BUILDING COMPLETION REPORT

With reference to your letter no B.S.C 306/41
date 21-1-42, I have to return the plans after
complying with your requirements as under:-

With reference to your application dated **20th December 1941** with a plan for the proposed buildings/additions and alterations on plot No. **33** Survey Sheet No. **B.R.5, Bunder** Quarter I have to request you to comply with the following requirements:—

PLAN SHOWING THE PROPOSED BUILDING ON PLOT No 33. B.R.5.

R.G. CHAWLA B.E. G.D. ARCH.
ARCHITECT & SURVEYOR.

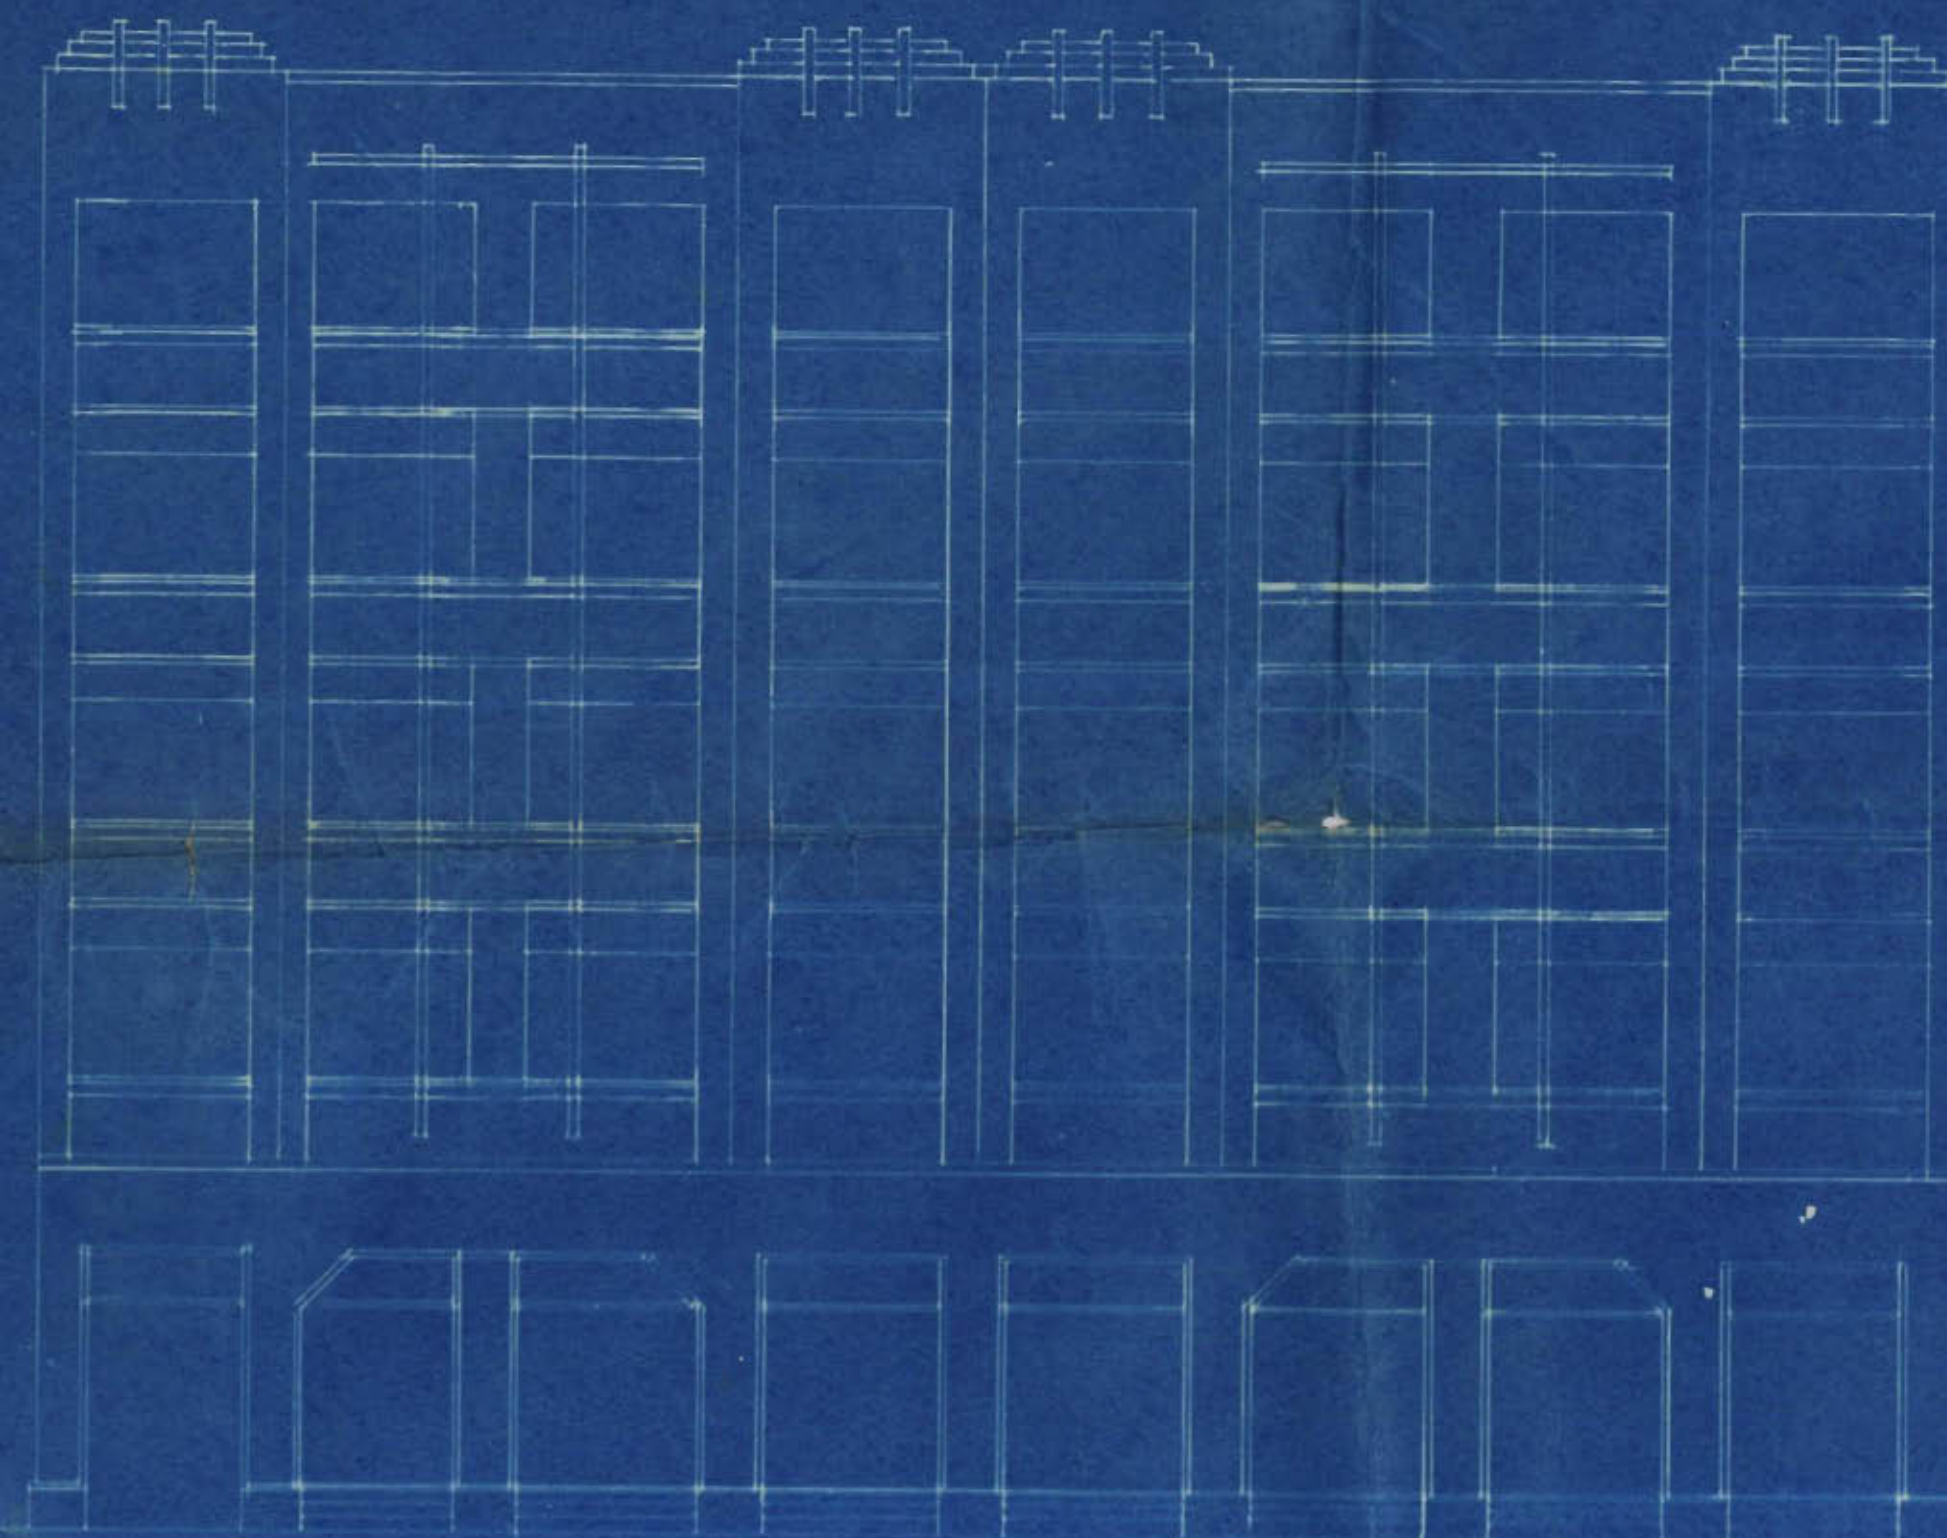
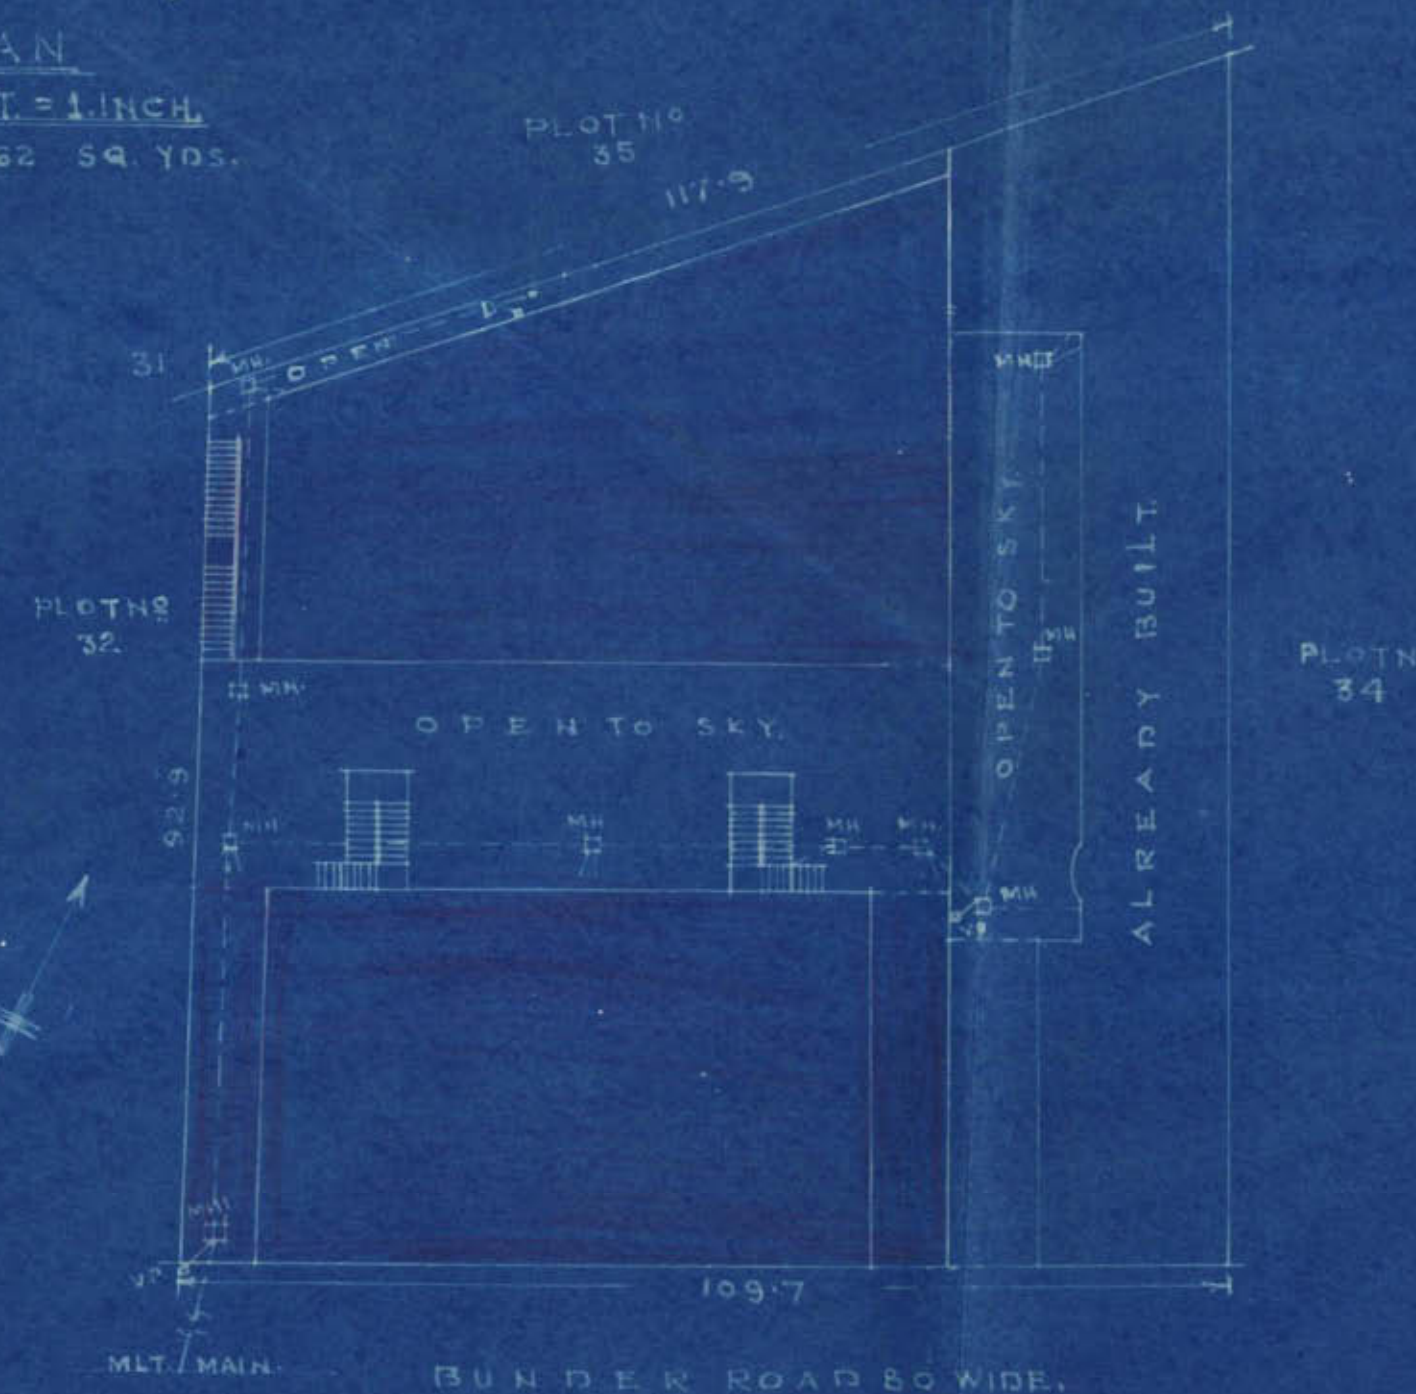
- (1) Please show how the baths and kitchens on upper floors in the rear block will be connected to drainage.
- (2) ~~Drainage~~ Amendments must be coloured red when the plans will be further considered.

- (3) Partition in the shop cannot be allowed.
- (4) The external partitions are ~~42~~ 32" with plaster which cannot be allowed.

1. Partitions in the shop cannot be allowed
2. The external partitions are $3\frac{1}{2}$ " with plaster which cannot be allowed

(1) Please show me the plan of the building as
upper floor is the last floor and is
connected to the ground floor by a staircase
which is closed and when the plan is
for further construction.

1) The arrangement for connecting both & between
in the new block is shown on the plan.

2) There is no special amendment. However
the new block drainage lines have been
coloured red.

3) Partitions in the shops have been provided
for giving a stone to the shop which is
lighted from the external open space
to which there should be no obstacle.

4) The external partition is required for external
wall in the new rules are 4" & 4" Even
brickwork which is only 2 to 2 1/2 inch work
have not been sufficient. There are no walls
for stone masonry & not for heavy masonry. The partition
may please be waived.

(1) The proposed drainage
arrangement for bath
& kitchen on upper floor
in the rear block & there
can not be allowed.

(2) All amendments
major or minor must
be cleared first as we
are coming over shops
& stores for which C.O.
sanction is necessary.
The B. Plan file No. 10 of 1941
is returned herewith pl.
